Construction Site Management Plan Checklist

Project Name: Gondola & Building B

Steamboat Logistics Base Improvements

CSMP Gondola Building and Building B Demo.

SITE PLAN - EXISTING CONDITIONS

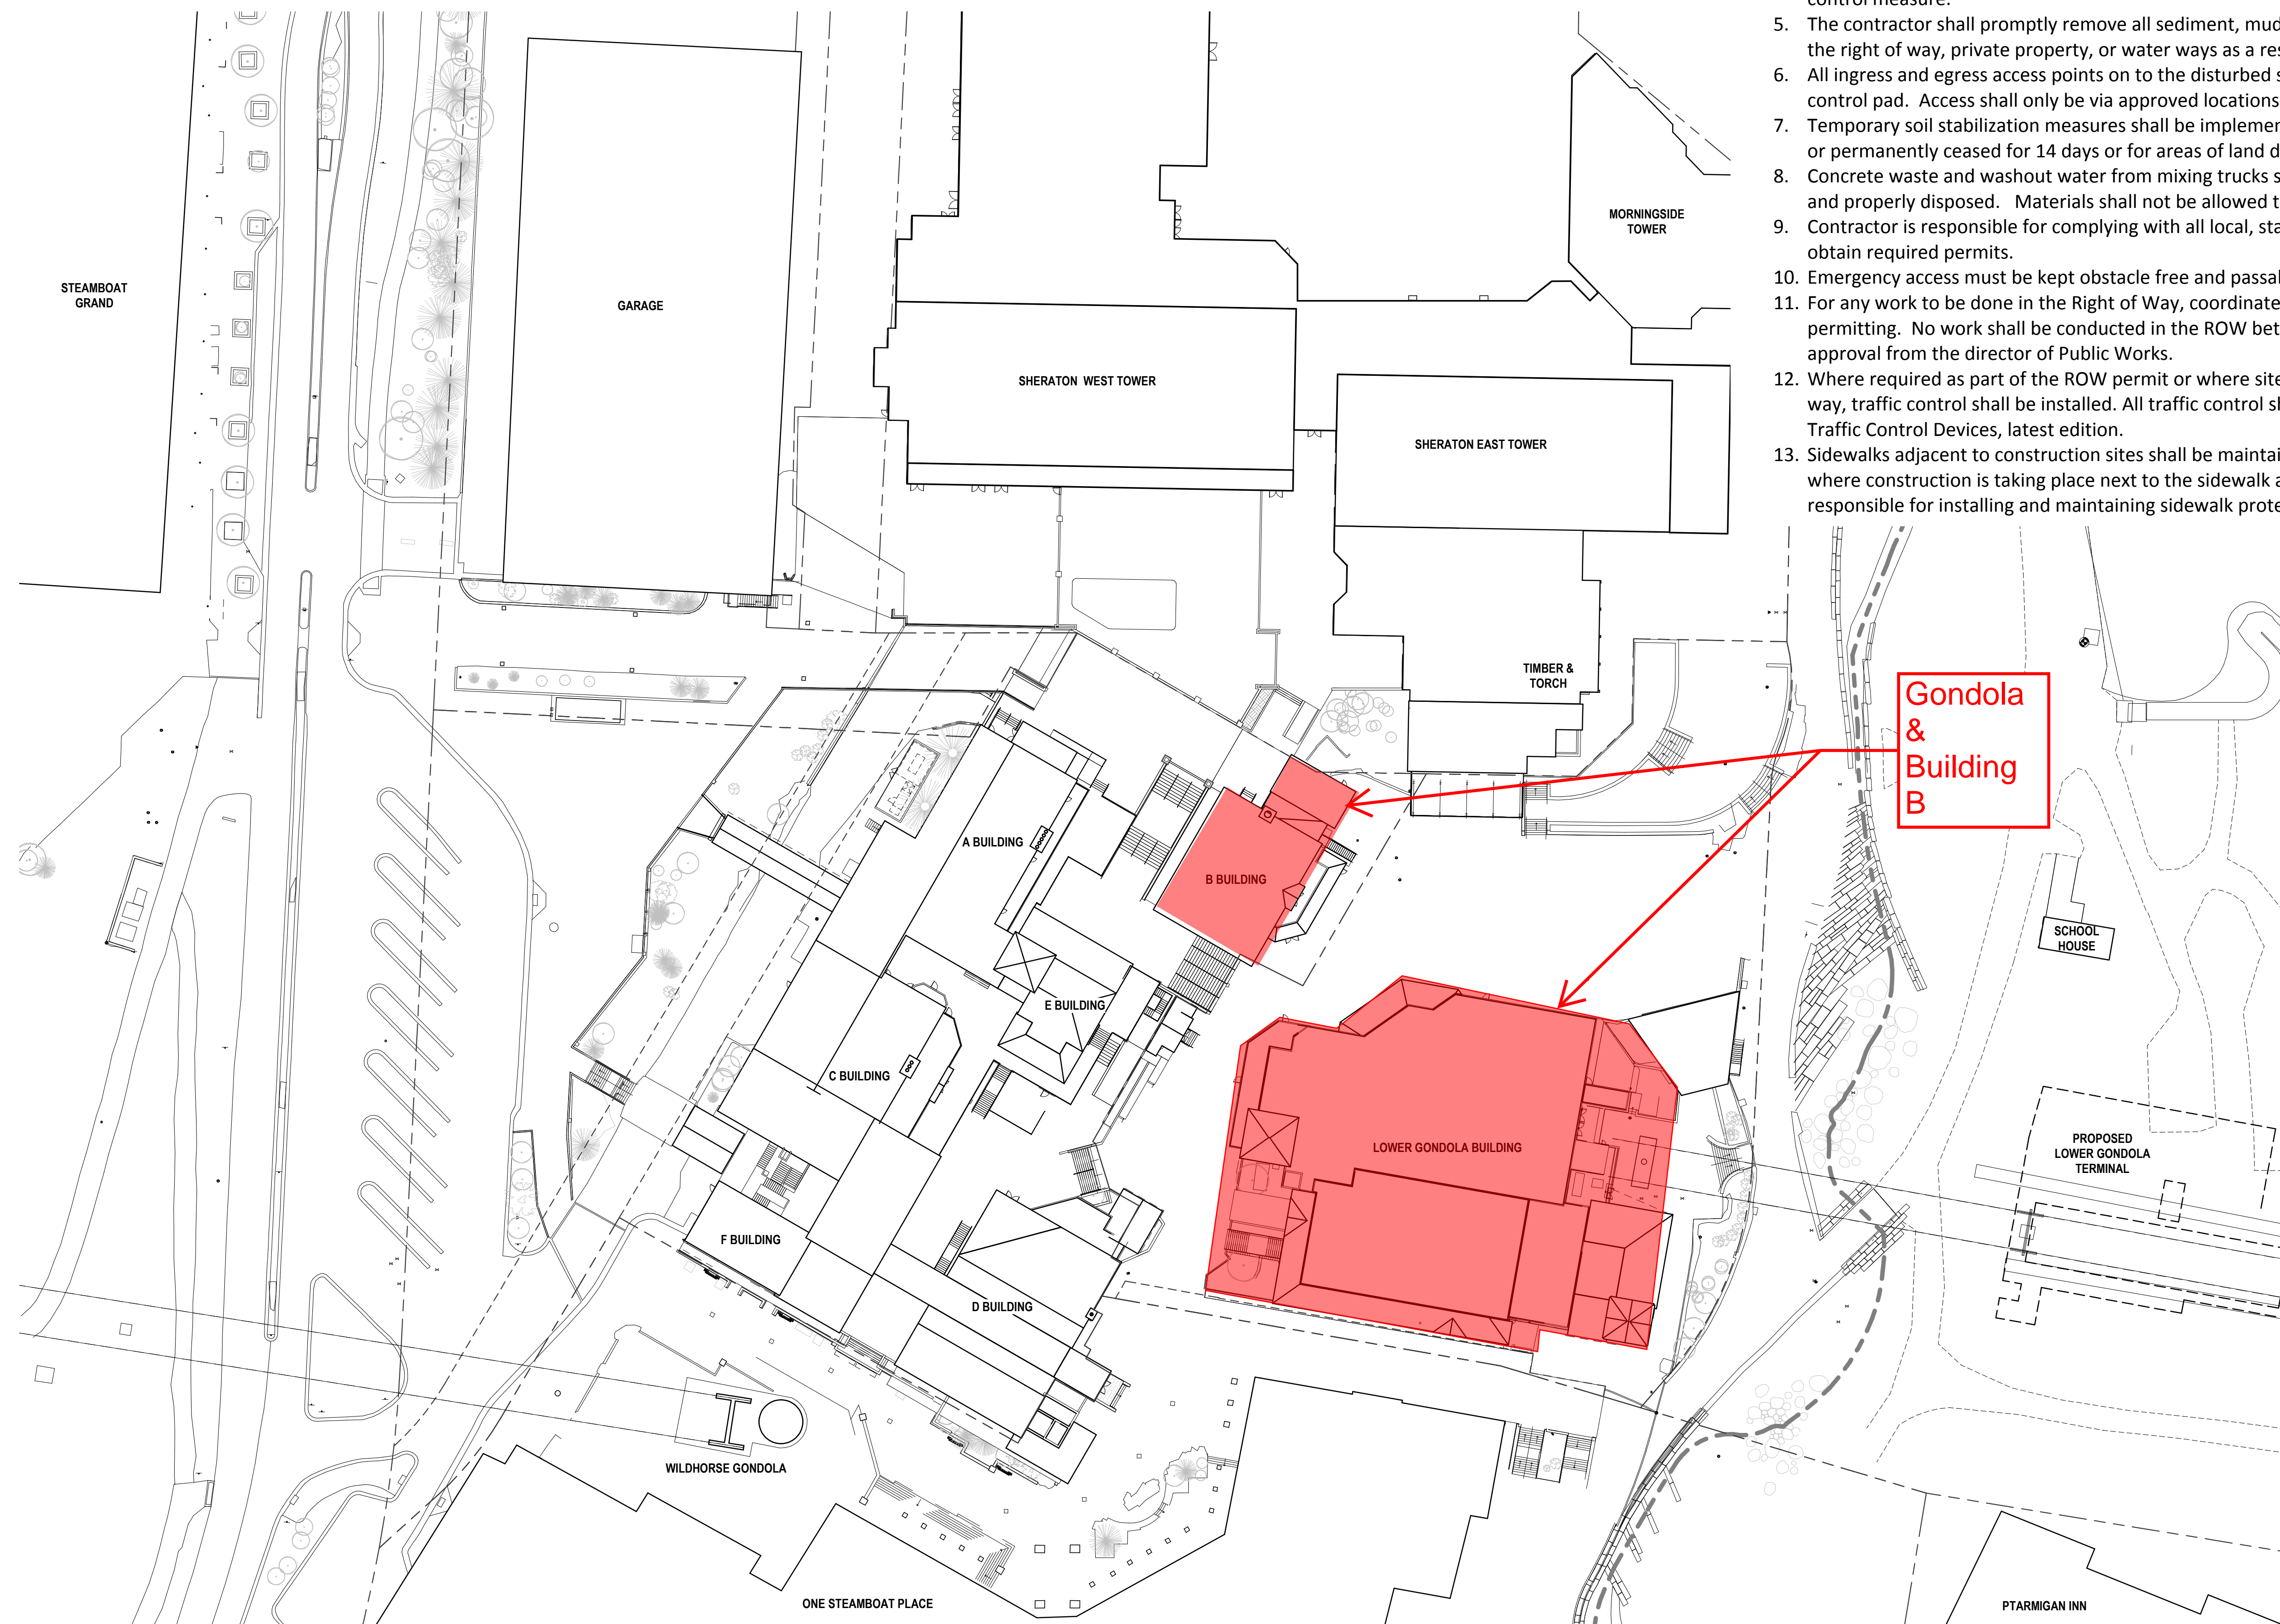
where on plan?
I see the details, i dont see the locations.

Ground water discharge?

Storm Inlet Plan

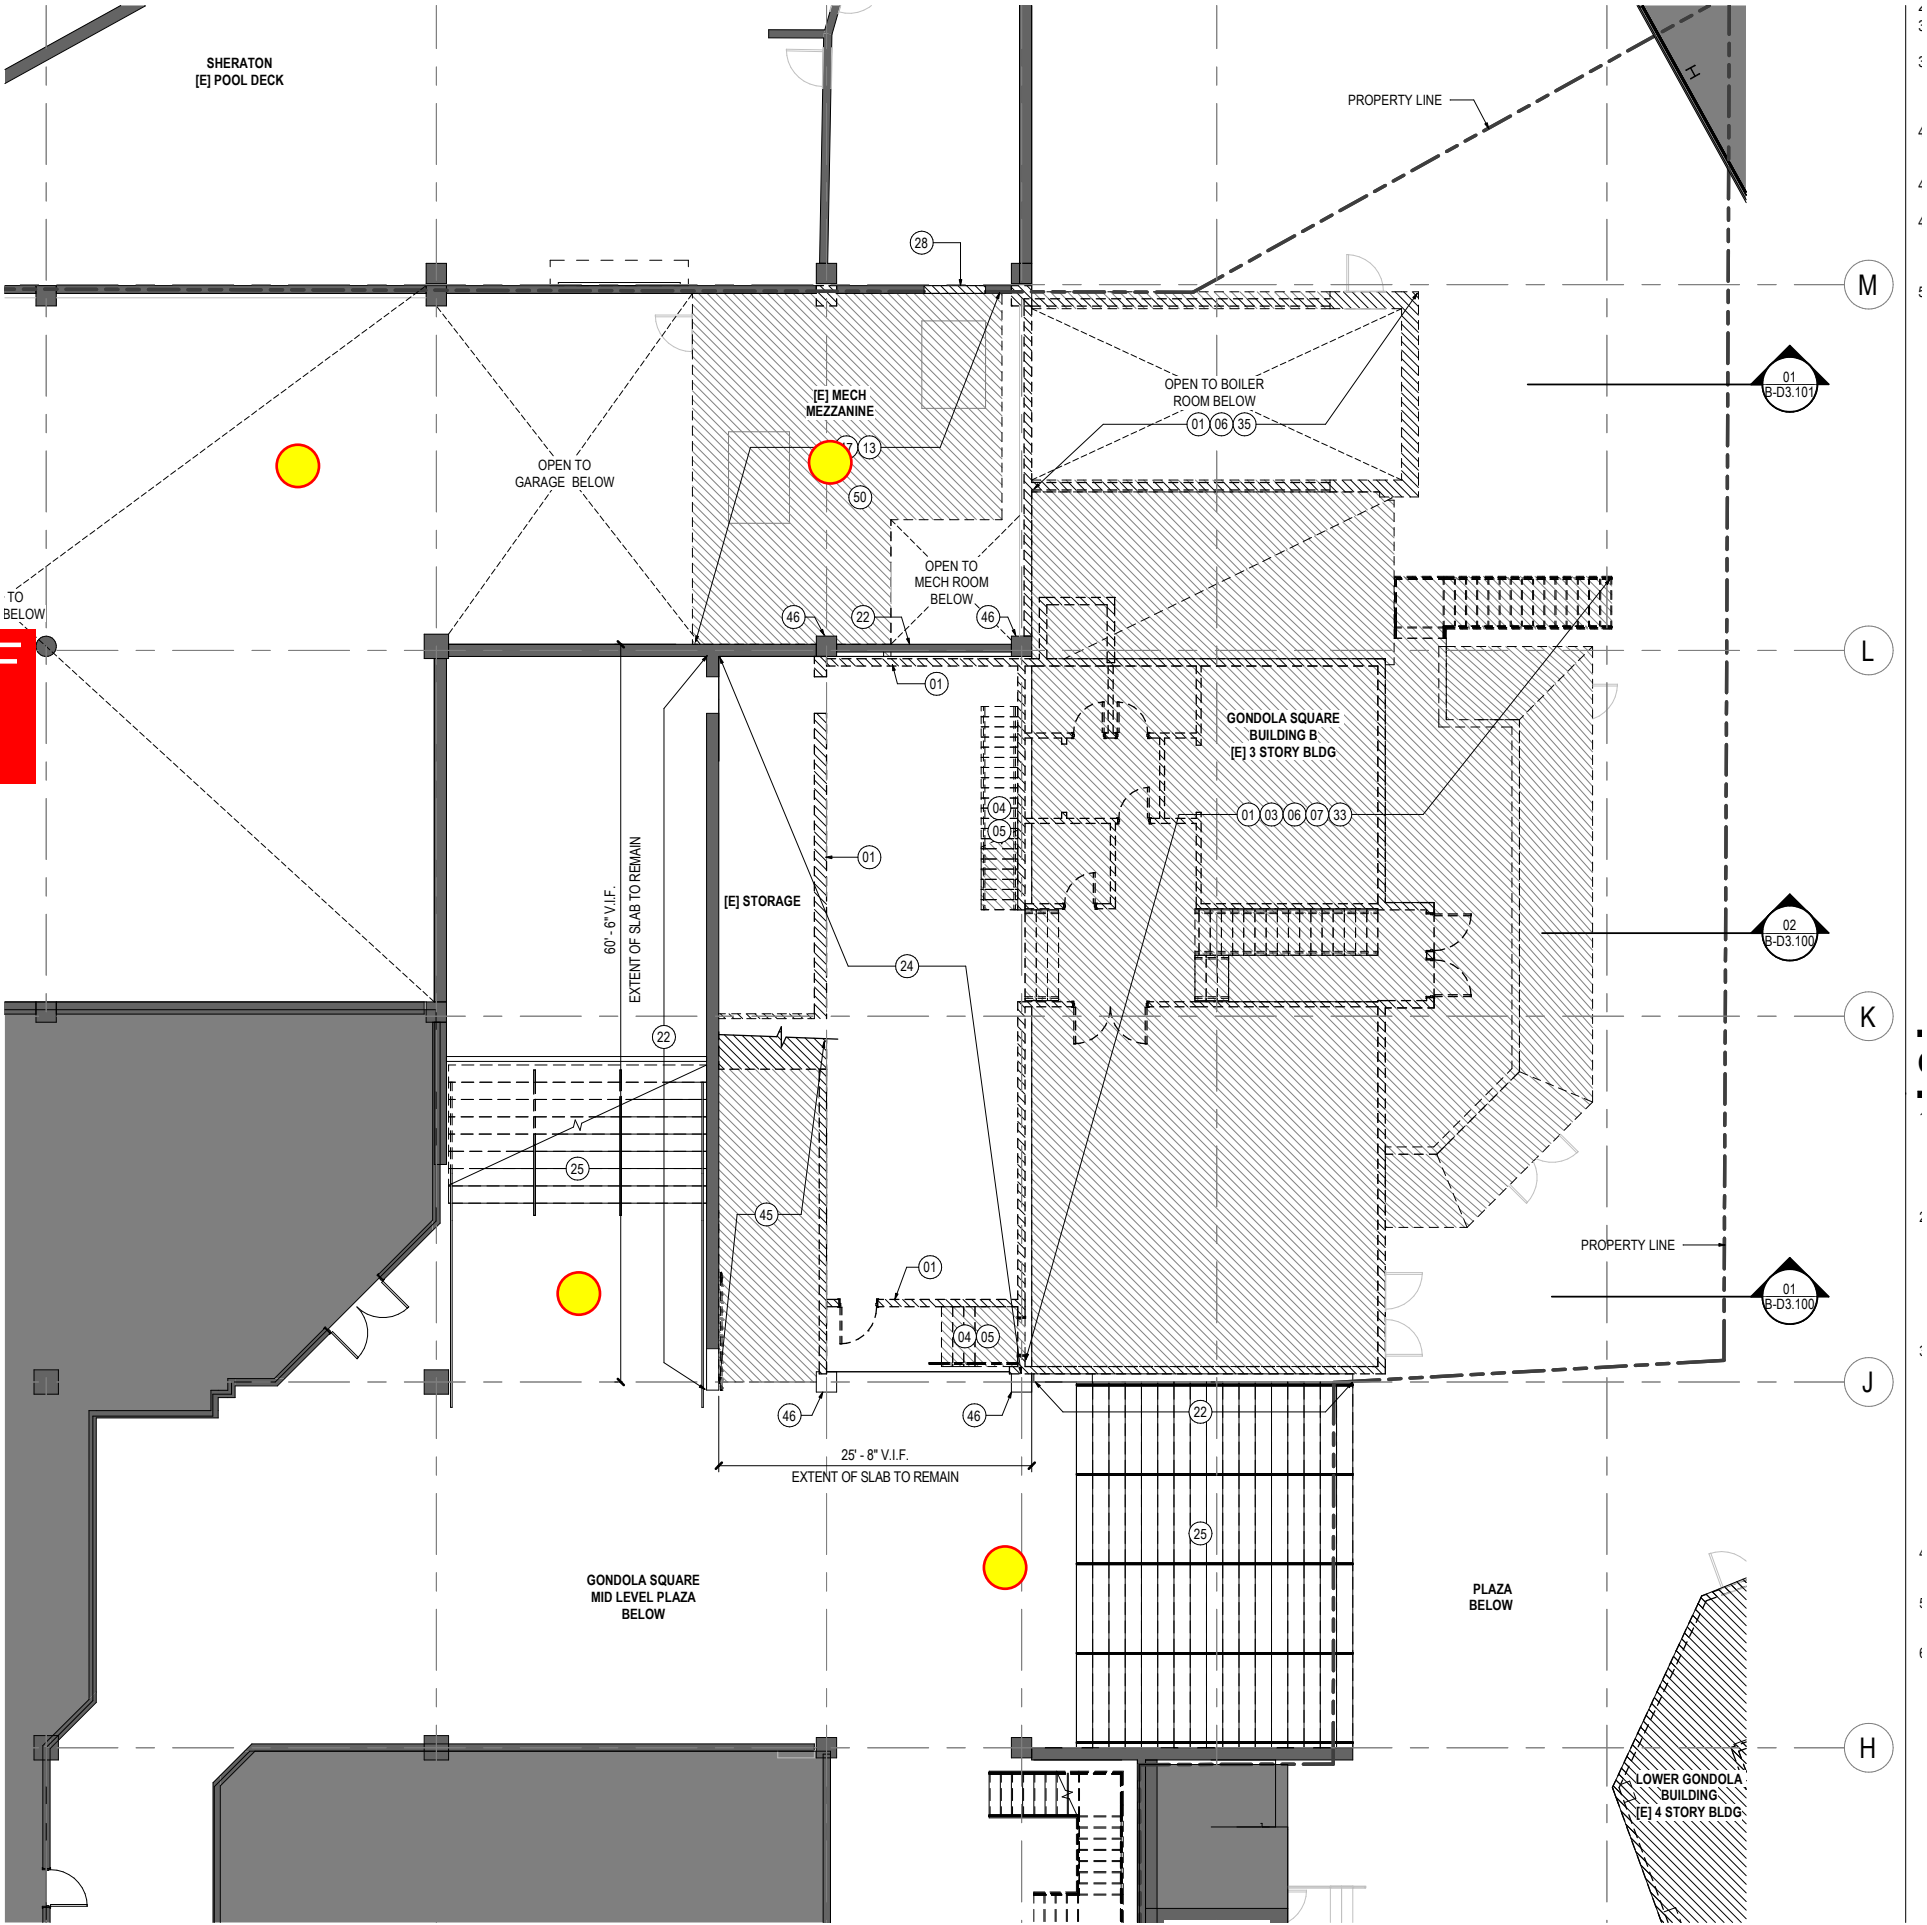
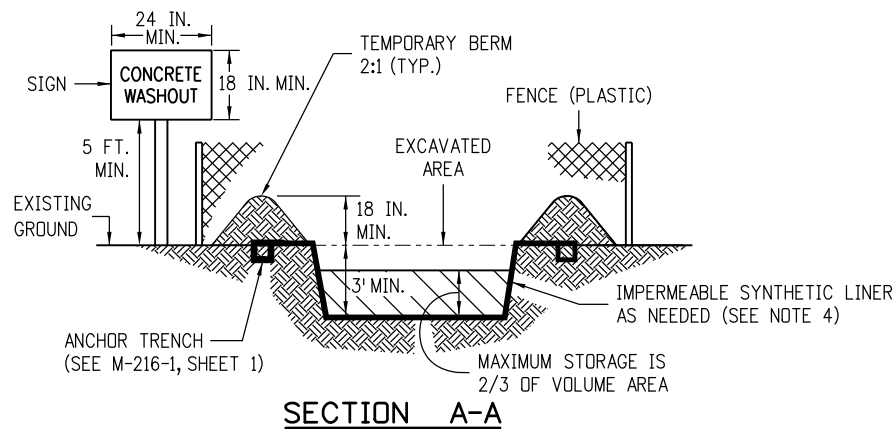
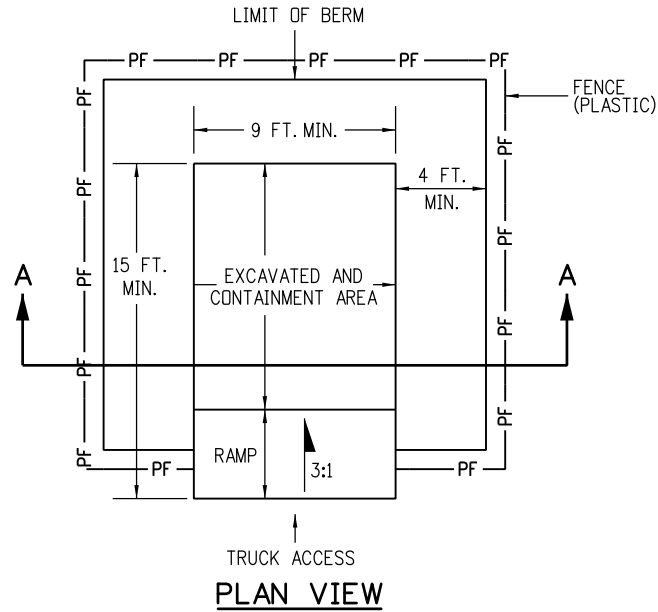
The Inlets highlighted yellow are planned to receive perimeter rock sock protection. The inlets further identified in red or blue outlines will potentially be cut and capped or are upstream. In those instances the inlets will not have the rock sock protection.

INLETS WILL BE PROTECTED IF NOT, CUT AND CAPPED.
